**STAFF RECOMMENDATION**

**1501 Lillian Street**  
**September 16, 2020**

**Application:** New Construction—Addition  
**District:** Lockeland Springs-East End Neighborhood Conservation Zoning Overlay  
**Council District:** 06  
**Base Zoning:** R6  
**Map and Parcel Number:** 08313044000  
**Applicant:** Dale Brackeen  
**Project Lead:** Melissa Baldock melissa.baldock@nashville.gov

<p><b>Description of Project:</b> Applicant proposes a two-story rear addition.</p> <p><b>Recommendation Summary:</b> Staff recommends approval with the following conditions:</p> <ol style="list-style-type: none"><li>1. The addition be inset two feet (2') at the existing back corners of the house;</li><li>2. The addition's roof slope be at least 6/12;</li><li>3. Staff approve all windows and doors prior to purchase and installation; and</li><li>4. Staff approve the HVAC location.</li></ol> <p>With these conditions, staff finds that the proposed addition meets Section II.B. of the design guidelines.</p>	<p>Attachments A: CARR 200306548 B: Site Plan C: Elevations</p>
---	---

1 EXTERIOR NORTH ELEVATION  
3/16" = 1'-0"

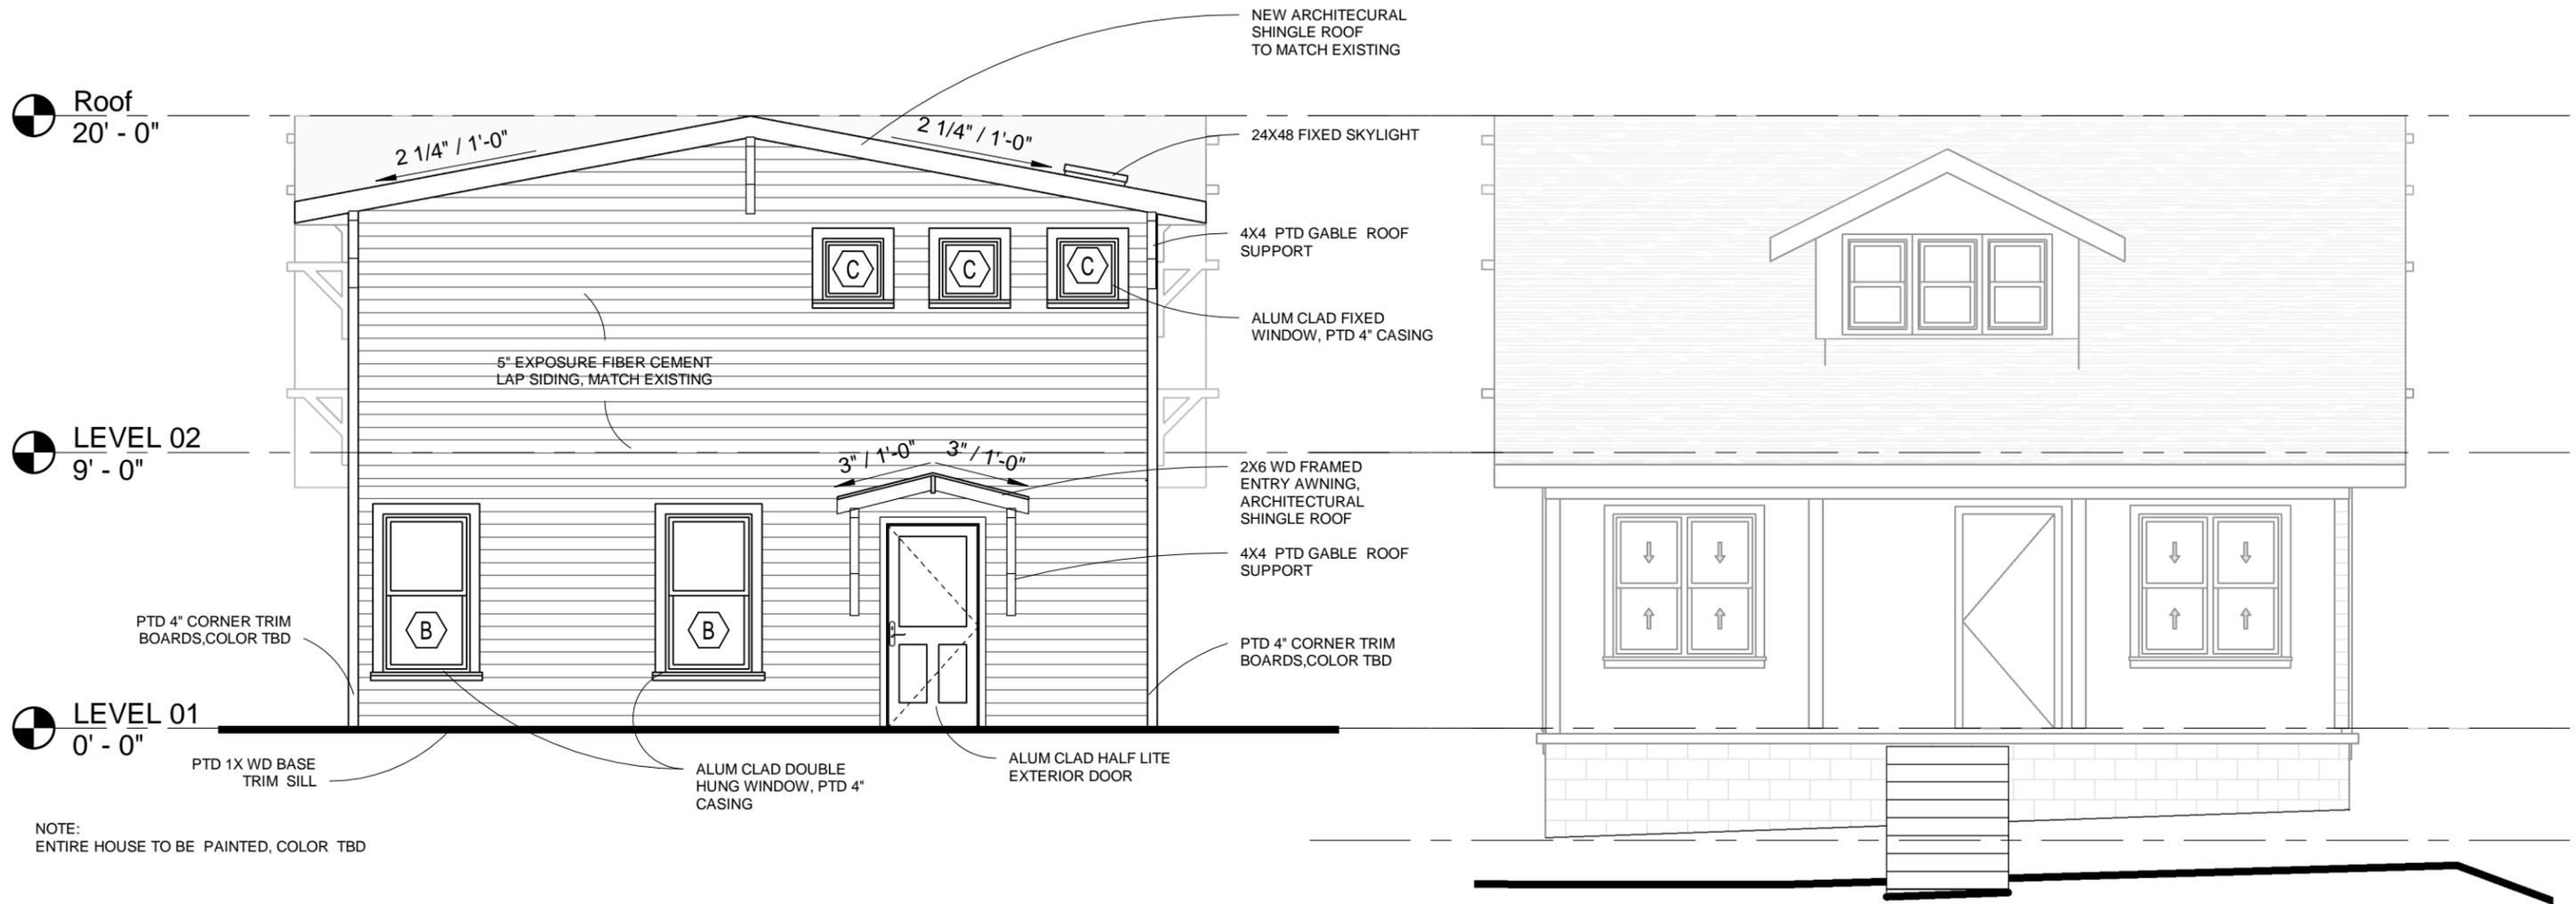
Height & Scale: The existing house is one-and-a-half stories at the front and two stories at the rear. The proposed addition is two stories in height with a ridge and eave height to match that of the rear of the existing. The addition is not inset from the side walls as is typically required. Although the house has been substantially altered, staff considers the house to be contributing and recommends that the addition be inset two feet (2') on both sides as is typically required of two-story additions. Particularly since the house is located on a corner lot and the addition will be highly visible, staff finds that inseting the addition two feet (2') will help keep the overall height and scale in keeping with the height and scale of the historic house while recognizing the changes that have taken place.

Roof form: The roof of the addition ties into the roof of the historic house at the ridge. The addition's roof form is a gable with a 2.25/12 slope. Staff finds that this low slope does not meet the design guidelines, which states that new construction, including additions, should have roof slopes of at least 6/12. Staff therefore recommends that the addition's roof slope be at least 6/12.

1. The addition be inset two feet (2') at the existing back corners of the house;
2. The addition's roof slope be at least 6/12;
3. Staff approve all windows and doors prior to purchase and installation; and
4. Staff approve the HVAC location.

2 EXTERIOR SOUTH ELEVATION  
3/16" = 1'-0"

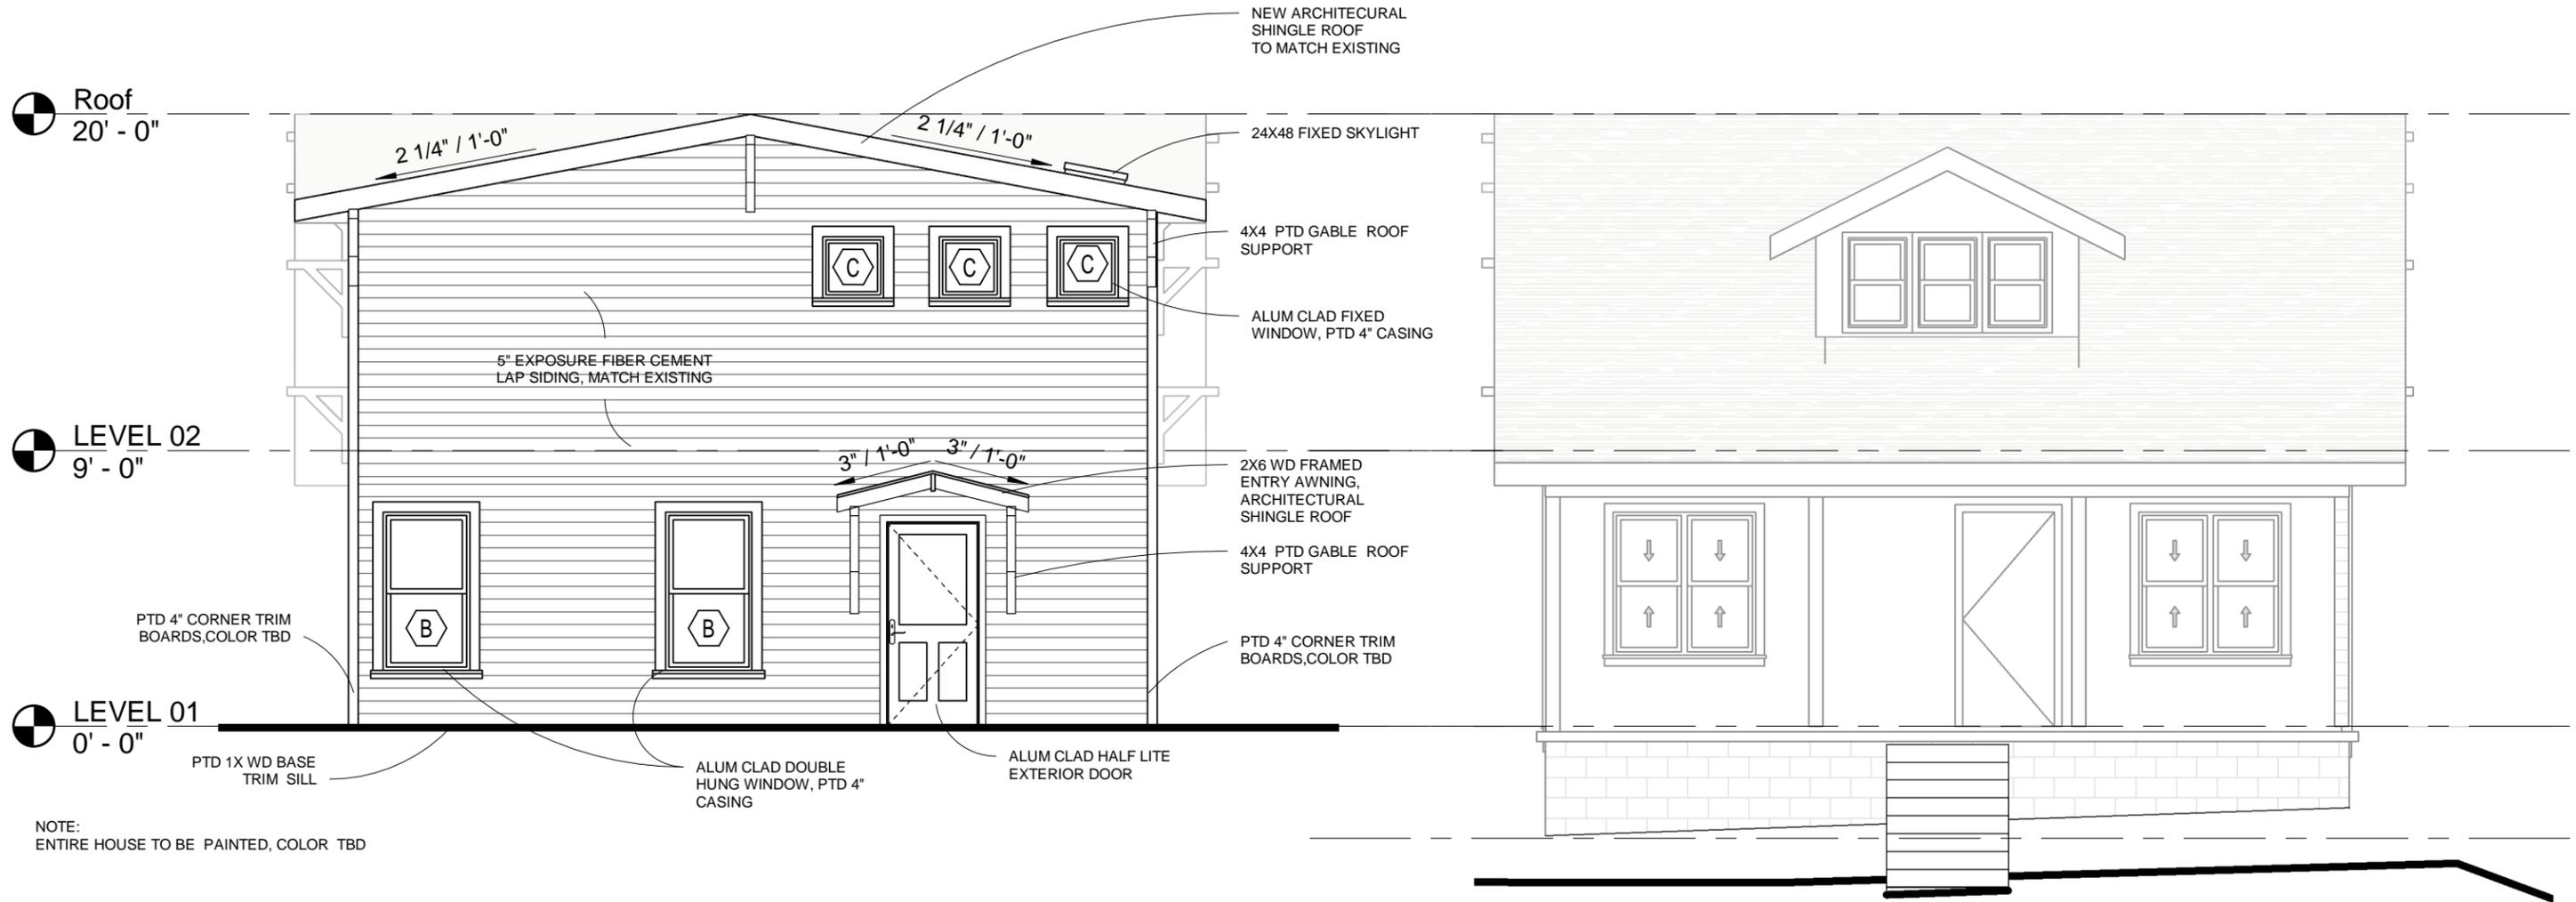
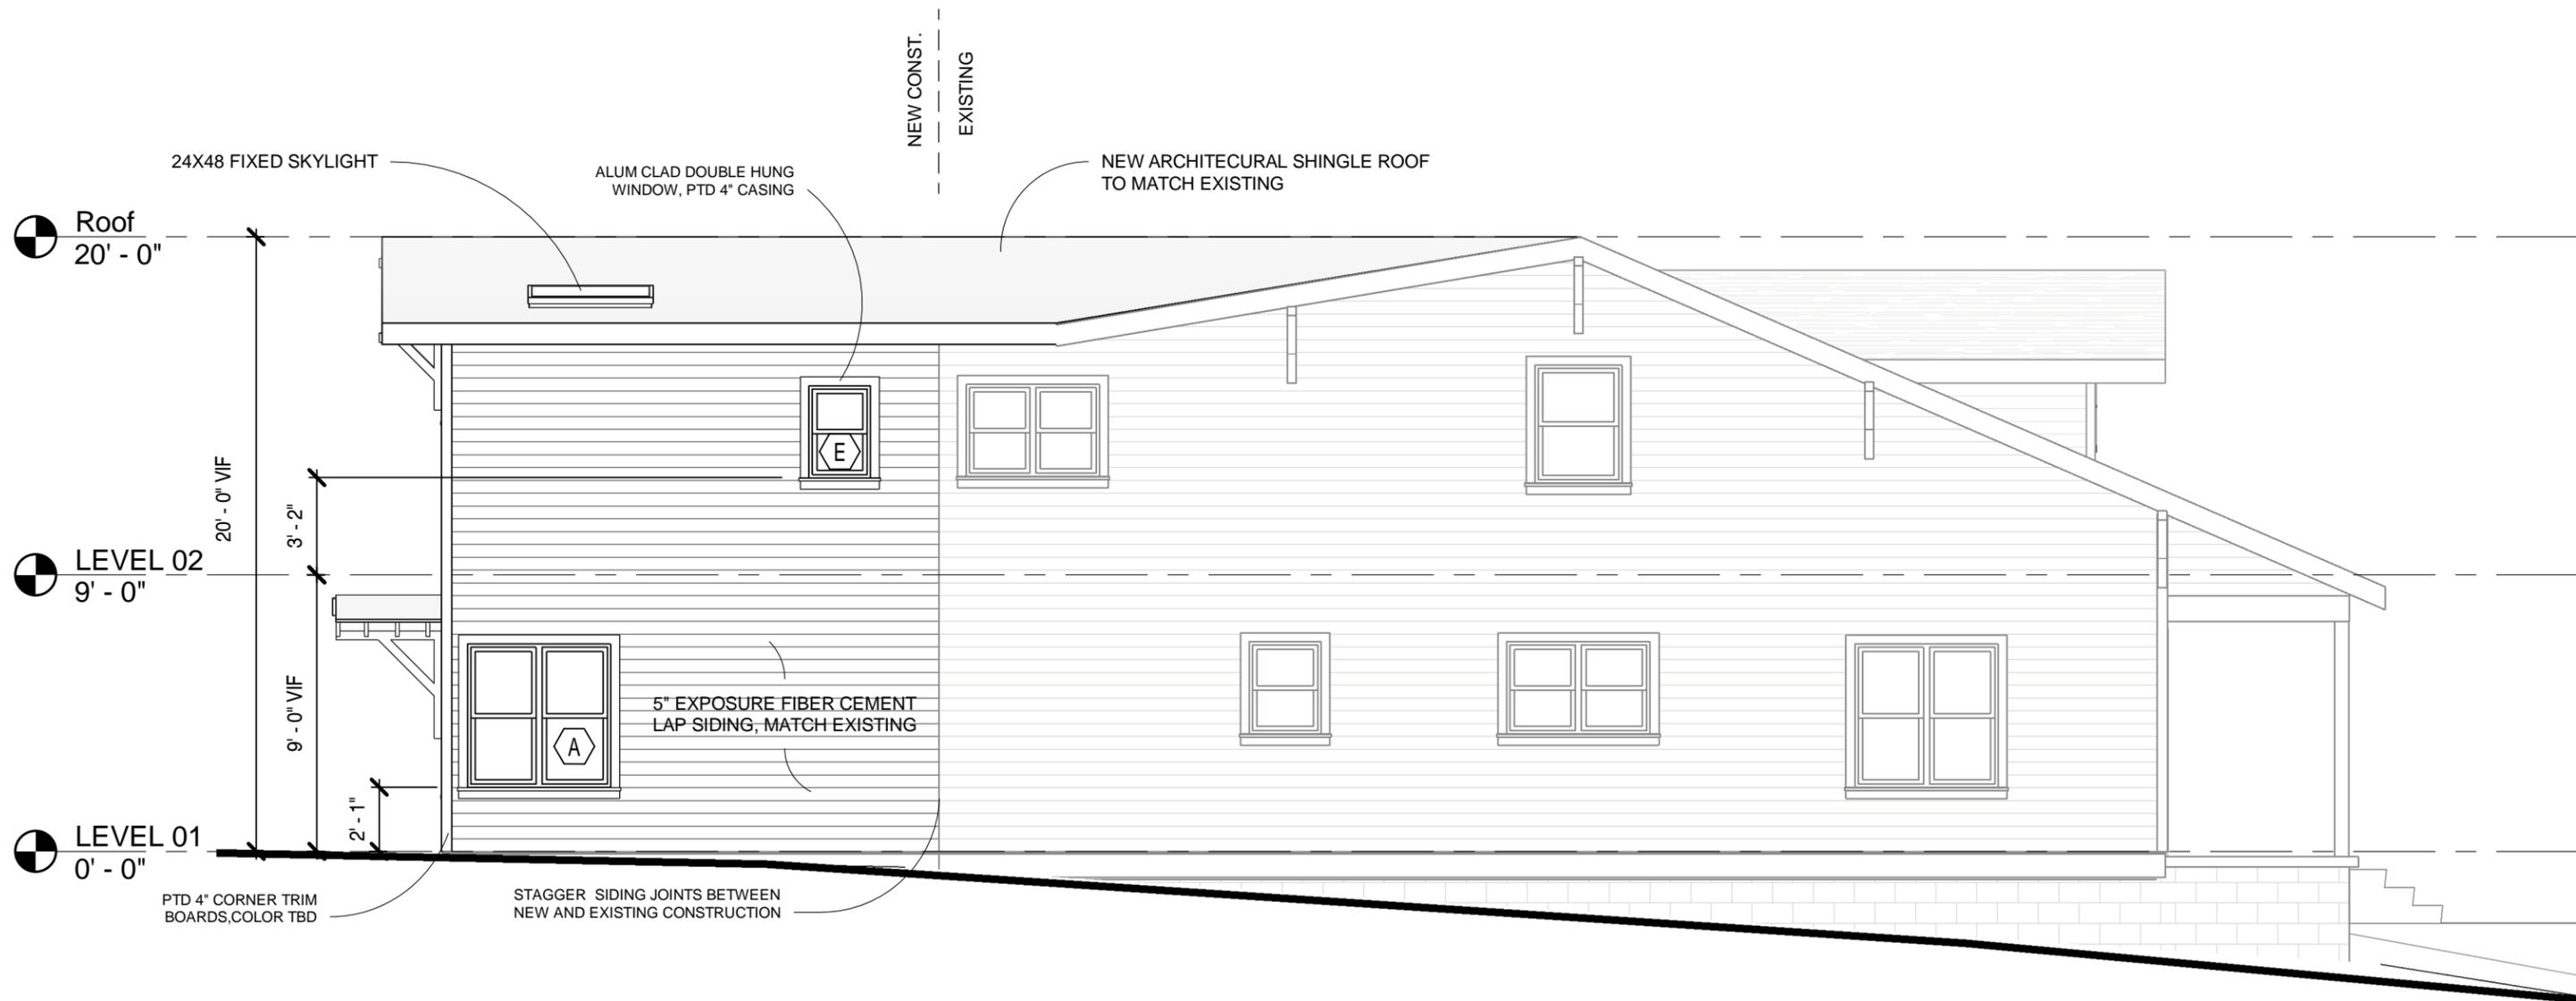
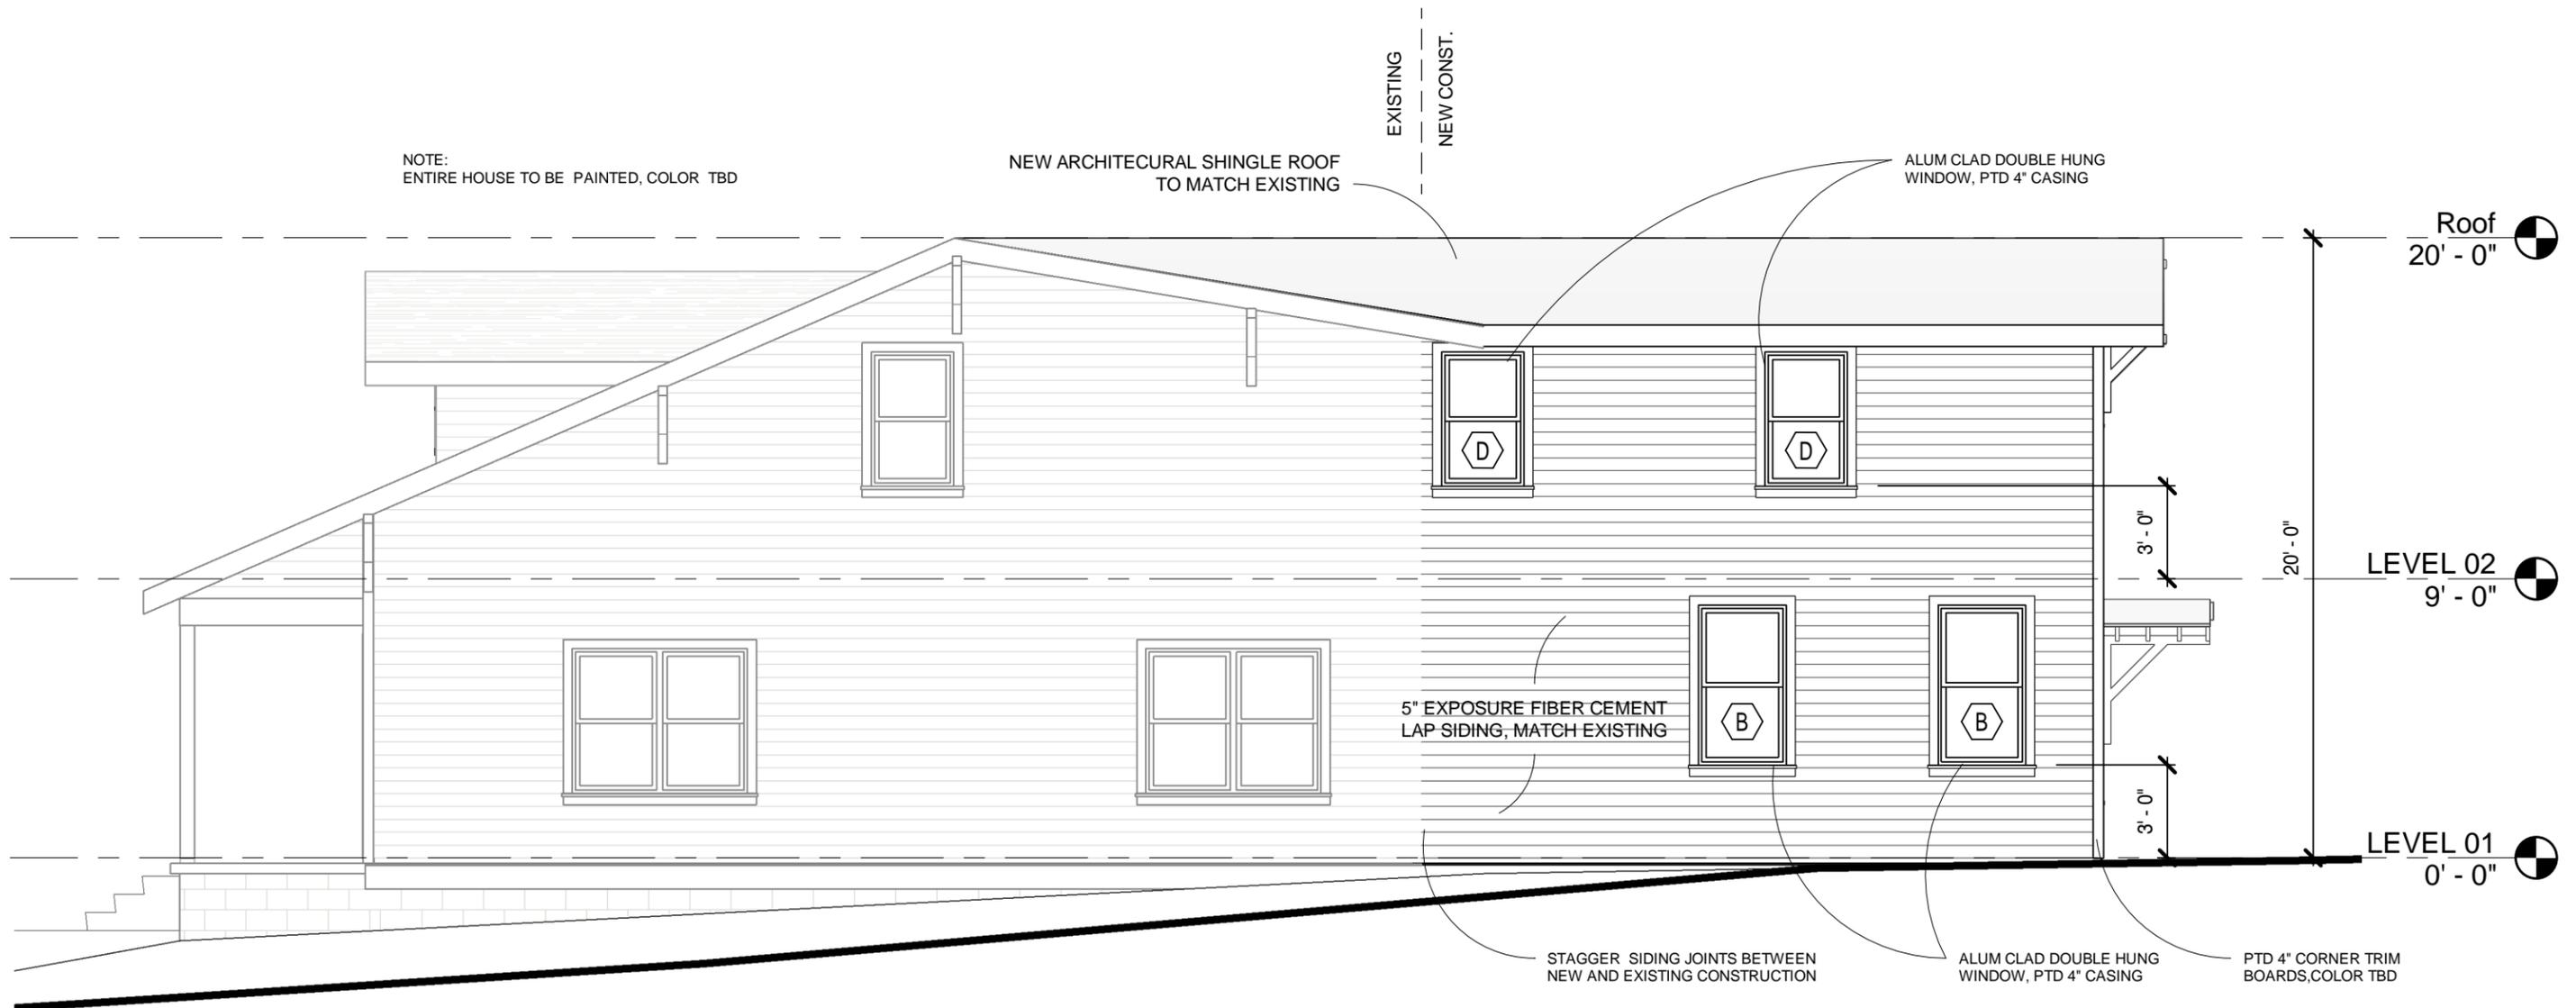
openings. On the South 15<sup>th</sup> elevation, ground floor, there is an expanse of twenty feet (20') without a window or door opening. If the addition is inset, as staff recommends, then the break in the wall and the inset will provide an interruption of wall space and an additional window or door opening is not needed.

With the condition that the addition be inset two feet (2') from the side walls of the historic house, staff finds that the project's proportion and rhythm of openings to meet Sections II.B.7. and II.B.10. of the design guidelines.
